REVISED September 24, 2025

Label Position Correction for Tape Reels for TVS Products

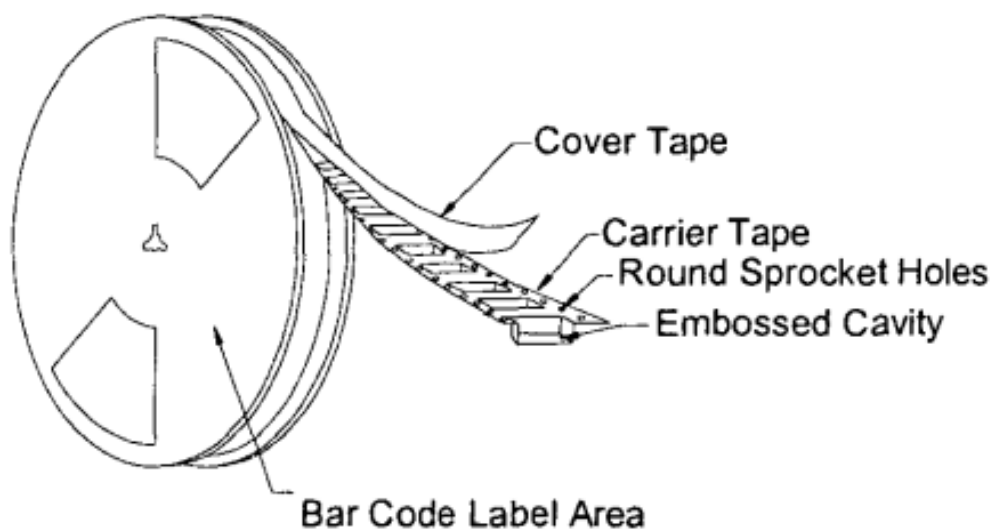
Riverside, California – September 12, 2025 – Effective September 29, 2025, Bourns corrected the label position of the tape reel to comply with the EIA-481 standard on the data sheet. According to the EIA-481 standard on the datasheet, the position of the packaging label on the reel should be on the opposite side of the round sprocket holes on the carrier tape. A list of affected part numbers is included below.

Below is an example from the EIA document ANSI/EIA-481-C-2003 illustrating how the label position will be changed to clearly indicate its location on the reel in accordance with the EIA-481 standard.
